Proposal for Corrigendum 1 to Supplement 9 to the 06 series of amendments to UN Regulation No. 16 (Safety-belts)

Note by the secretariat

The text reproduced below is amending ECE/TRANS/WP.29/GRSP/2017/21 prepared by the expert from the Netherlands to correct typos. The modifications to the existing text of the UN Regulation are marked in bold for new or strikethrough for deleted characters.

"4. Booster seat child restraint system fixtures:

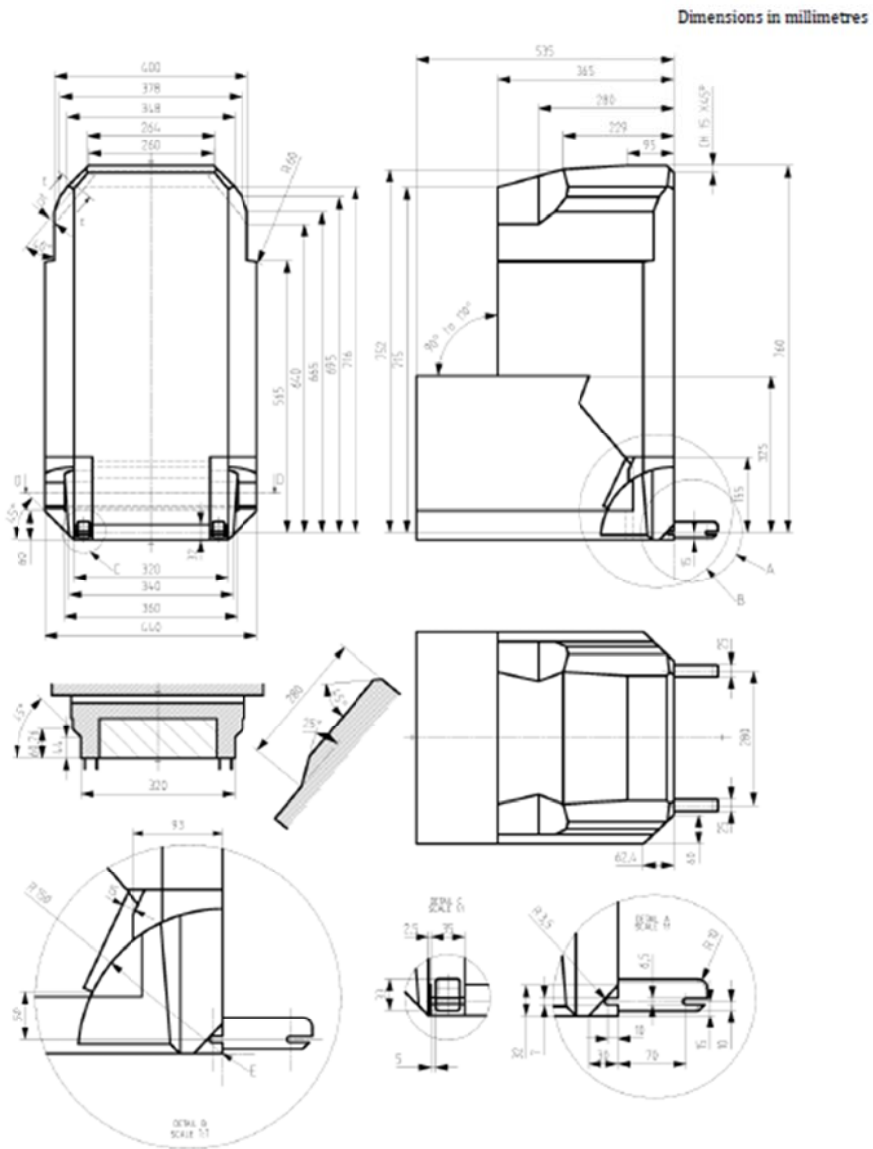
The fixtures above shall be constructed with a mass of 7 kg +- 0,2 1 kg and shall be of suitable durability and stiffness to satisfy the functional requirements."

"Figure 3

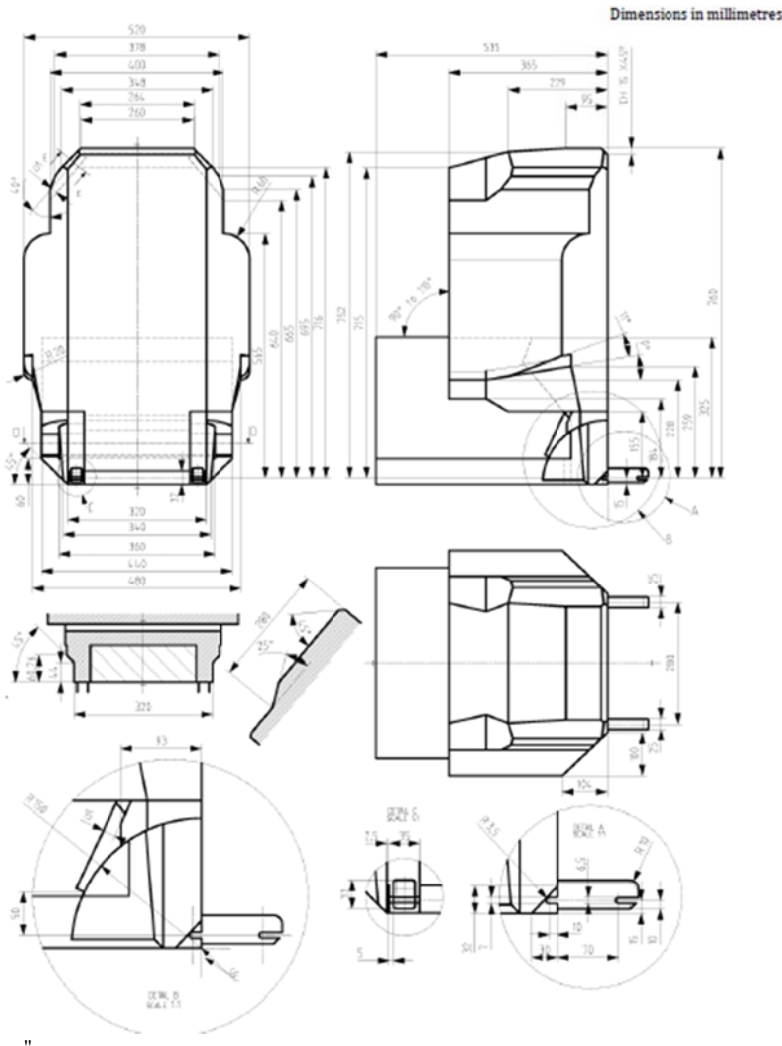
Appendix 5, Figure 3 ISO/B3, to be replaced as follows:
